Development Permit Panel

Re: Application by Omicron Architectural Engineering Construction Ltd. for a
General Compliance Ruling at 15111 Williams Road and Richmond Key 195105

Overlay Plan Showing The Existing And Proposed Pierson Road Alignment

Figure 1
"Triangle Lot" Habitat Plan:
March 2016 & November 2017

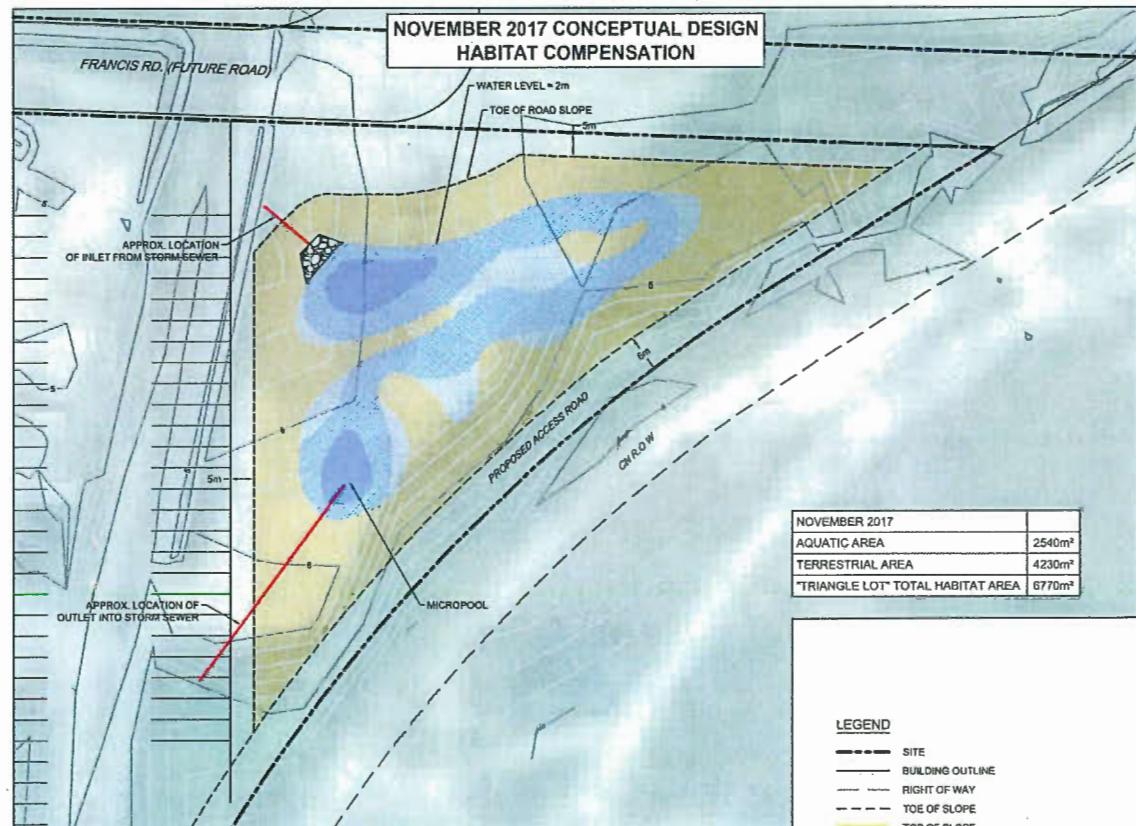
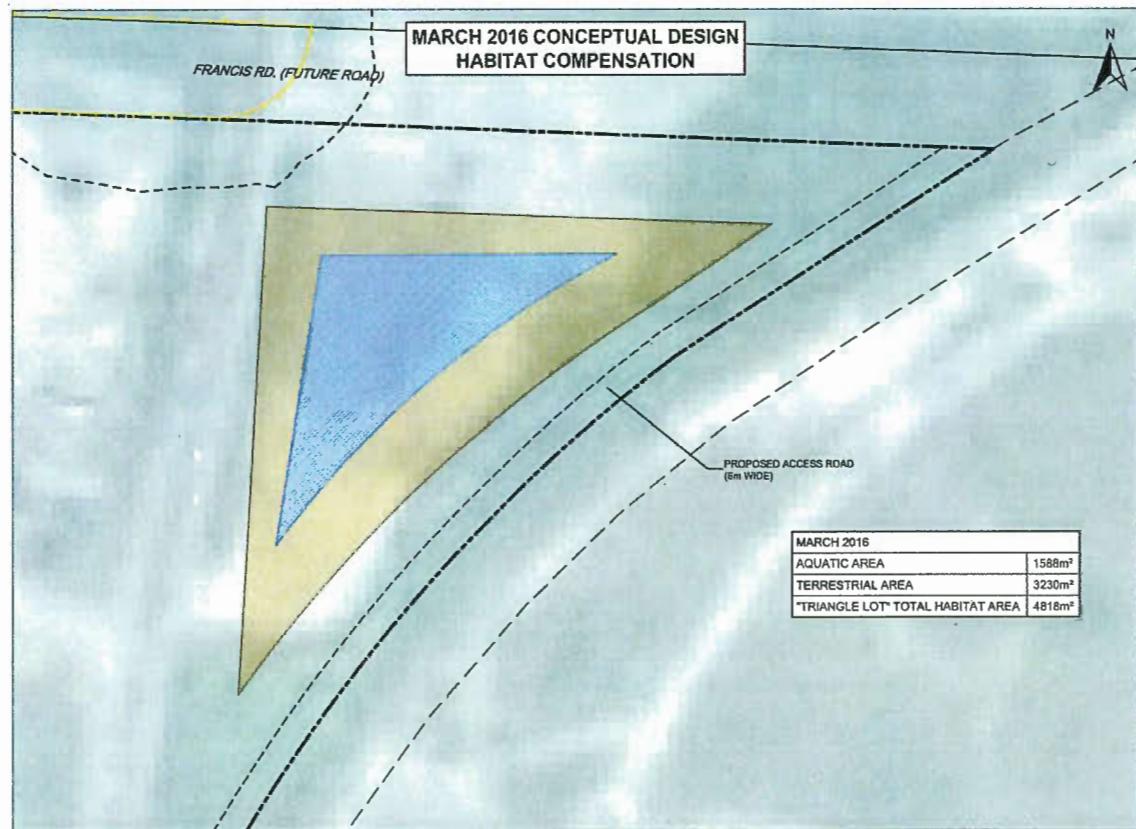
The proposed road realignment will require changing the design slope of the wetland to 3 (H) to 1 (V), the previous design allowed for a 4 (H) to 1 (V) design slope. The proposed riparian planting plan for the wetland will be revised to include plant species suitable for the increased slope. Tree species, including western redcedar (*Thuja plicata*) and Sitka spruce (*Picea sitchensis*), originally proposed for the sloped areas on the north and west sides of the wetland is planned to be replaced with Pacific willow (*Salix lucida* ssp. *lasiandra*) and hooker's willow (*Salix hookeriana*), which are more suitable for slopes that may become seasonally inundated. This does not preclude planting of larger coniferous trees, such as cedar or spruce outside sloped areas. Additional trees is planned to be included on the flatter riparian area on the southeast side of the wetland. A detailed revised planting plan will be submitted to the City of Richmond for approval.

As requested by the City, changes to the wetland compensation areas as a result of the road realignment will be compared to the March 2016 values. The March 2016 and revised November 2017 Habitat Balance Sheets are provided as an attachment to this letter, highlighting changes to the “Triangle Lot” compensation wetland areas.
